TENNESSEE VALLEY AUTHORITY

KINGSTON FOSSIL PLANT

ANNUAL ASH POND DIKE
STABILITY INSPECTION
2008

Prepared by: Jamey Dotson
Date: February 15, 2008

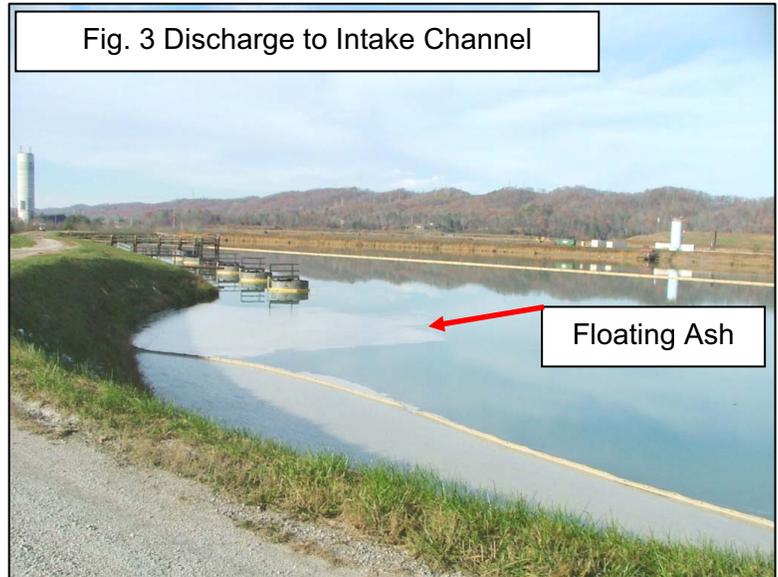
Large amounts of floating ash have been contained within floating skimmer booms (two inside both the active ash pond and the stilling pool). This ash should be removed in order to prevent an accidental release. Some of this ash has breached the booms and is near the discharge structures. See Figure 3. The seeps along the toe of Dike C and below the toe of the dike along the intake channel, known since the early 1980s were not visible during this inspection.

- Remove ash floating on the surface of the ash and stilling ponds.
- Repair rutting in the access and dike roadways. Fill with bottom ash and regrade as required to promote drainage.

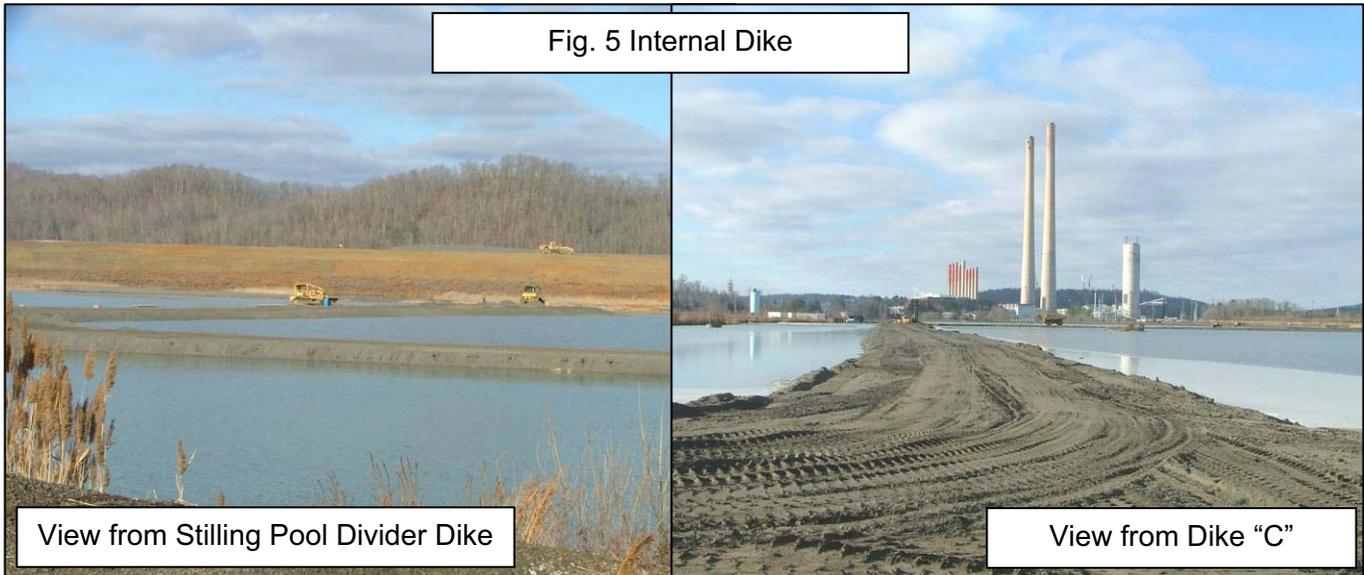
Some of the dike roads exhibit areas of rutting, see Figure 4. This photo is typical of the conditions of the roads, although it does not appear to be a significant problem

Fig. 10 Trees near Discharge to Pond

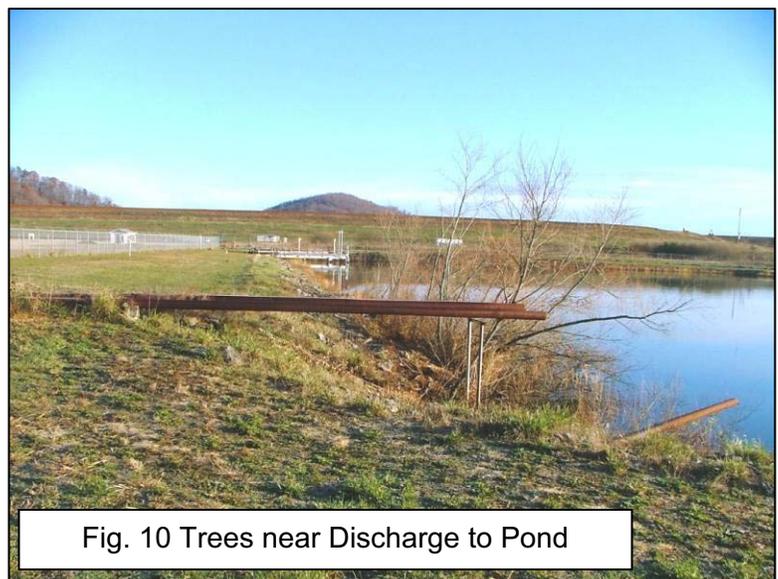
The chemical treatment ponds (iron and copper) are located southwest of the active ash pond. Both ponds were excavated and have no exterior slopes. The internal dike slopes are covered with riprap. These slopes were in good condition with a few trees present. See Figure 10. Sediment in the ponds was tested in FY 2004 and found to be non-hazardous. It appeared that some maintenance had been recently performed at one of the pond platforms. Old gaskets were on the ground and there was a new pipe flange and hardware. The platform at the smaller pond was missing a pump.

- Remove trees from the slopes of the dikes. Mowing at least twice a year is recommended to control the size of the trees. Preventing the trees from getting larger than 1" in diameter at the ground is preferred. Any trees larger than 3" in diameter at the base must be pulled from the dikes, roots and all. Repair and reseed the damaged area.

Fig. 12 Engineered Wetlands

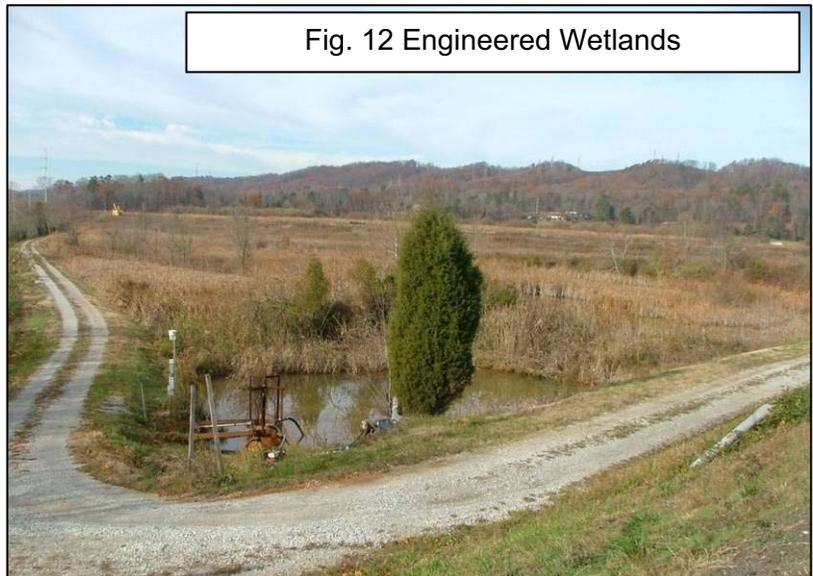
The engineered wetlands along the southwest dike receive seepage that collects in the anoxic limestone drain below the bottom ash trench. The wetland appeared to be functioning, but the discharge is still pumped via two pumps to the ash pond, see Figure 12.

The water levels in the pump structures were at different levels at the time of inspection. There were several trees varying in size growing on the interior dikes of the ponds.

API 2008-2

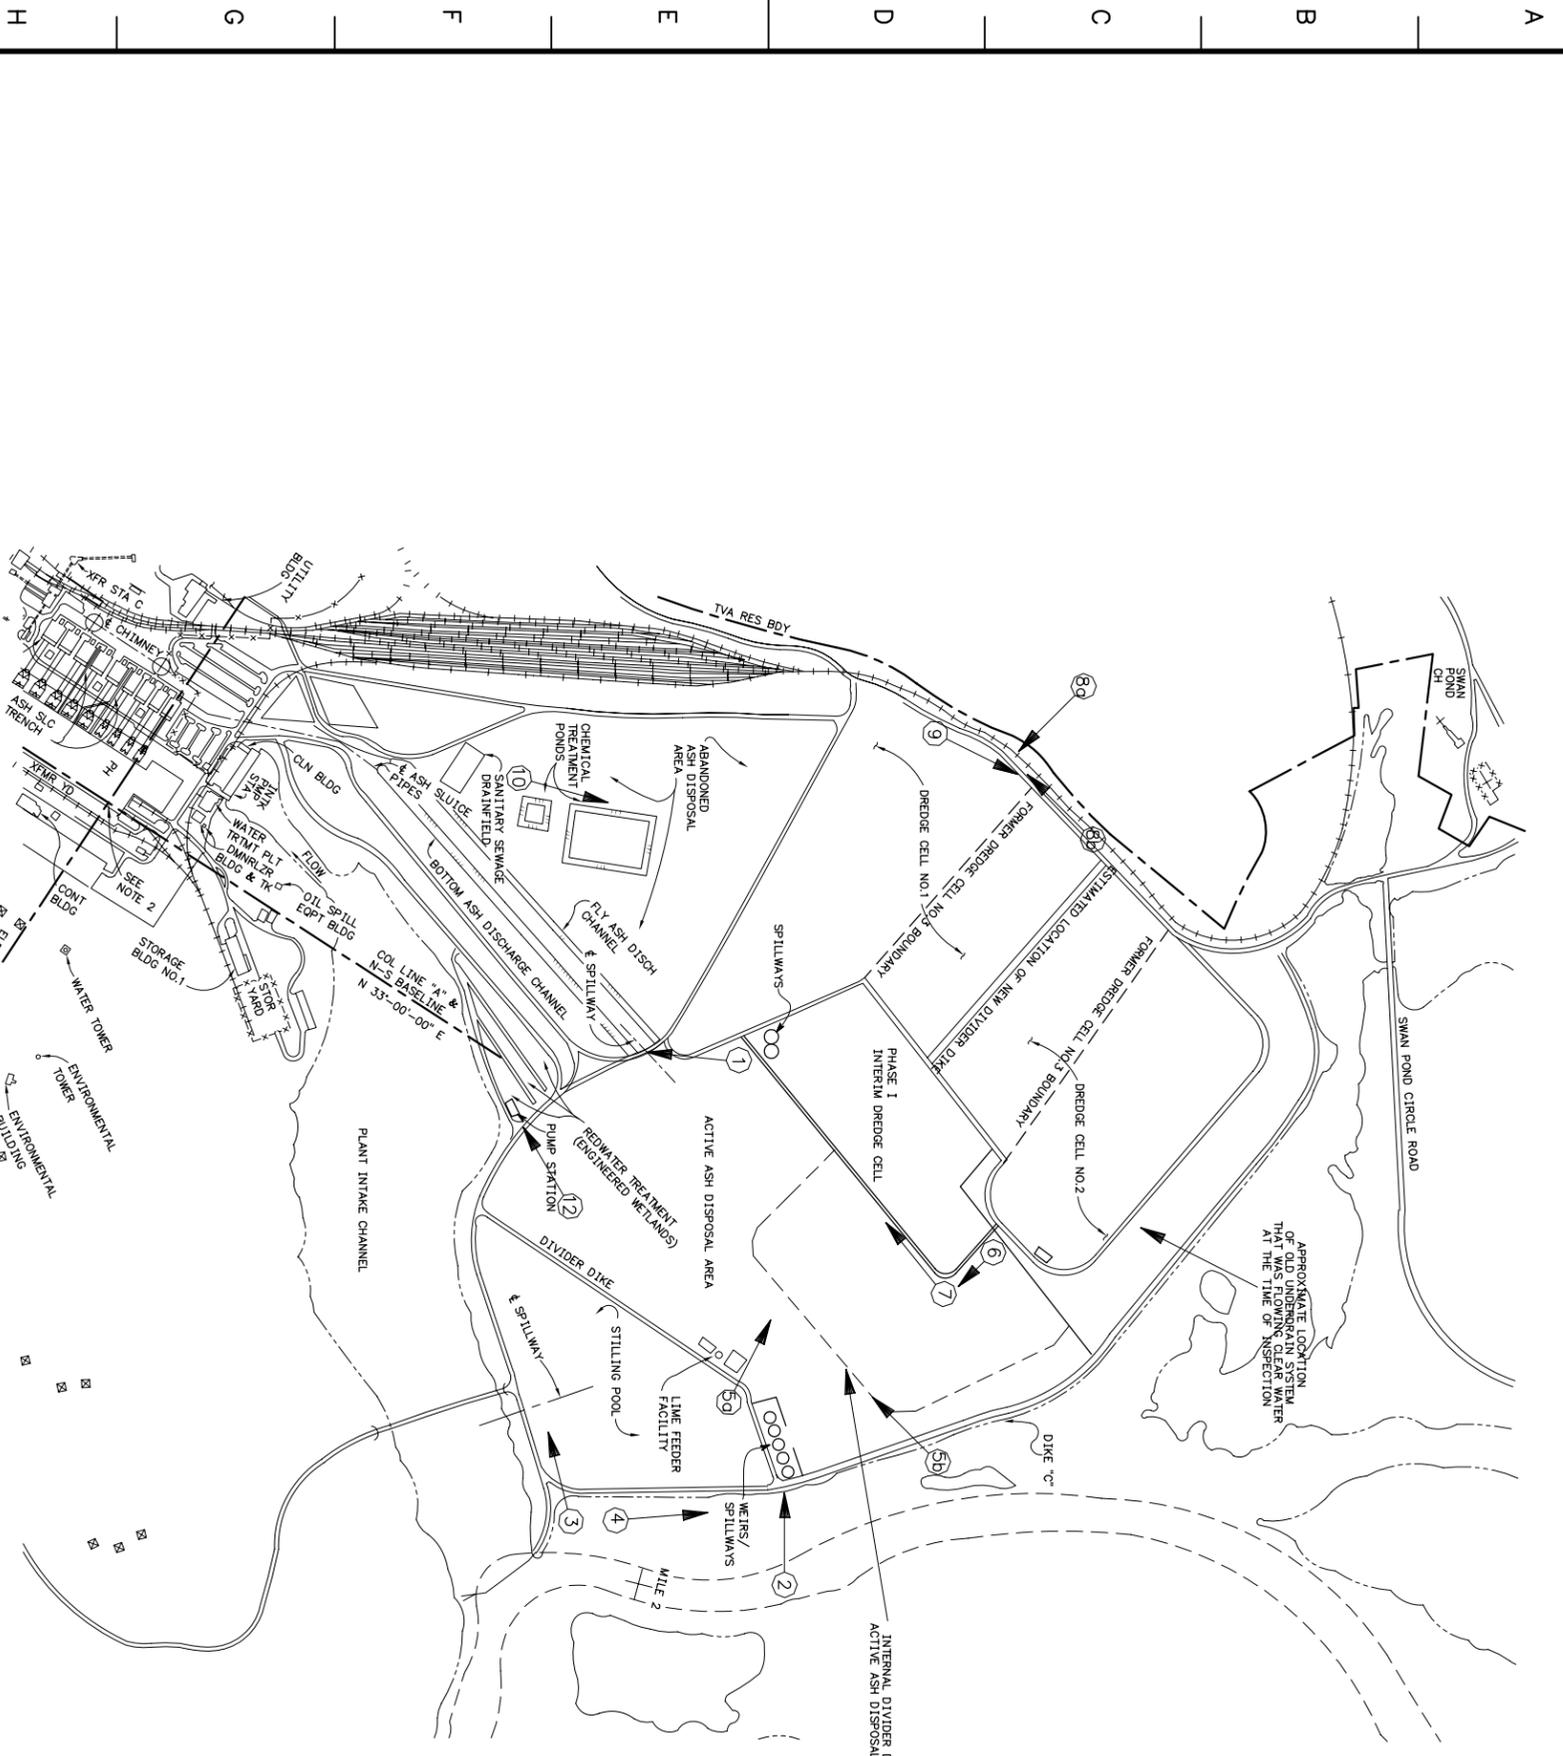
storage volume contained coal yard sediment. The above figure shows rock check dams built to keep the coal fines away from the pumps. The check dams appear to have been breached, allowing suspended solids to reach the pumps. TVA drawing 10W225-2 (attached as API 2008-2) shows the pond and its intended bottom contours.

- Dredge the Coal Yard Drainage Basin to restore its design contours and protect the pumps from further damage. There is an estimated 2,800+ cubic yards of sediment in the original pond and an extra 3,400+ cubic yards in the "V" section that needs to be removed as soon as reasonable. See the attached copy of 10W225-2. Estimated at \$55,000, depending on haul distance.

- Continue intermittent dredging into the interim dredge cell to inhibit fugitive dusting.
- Re-establish riprap check dams in the coal yard drainage basin to prevent solids away from the pumps.
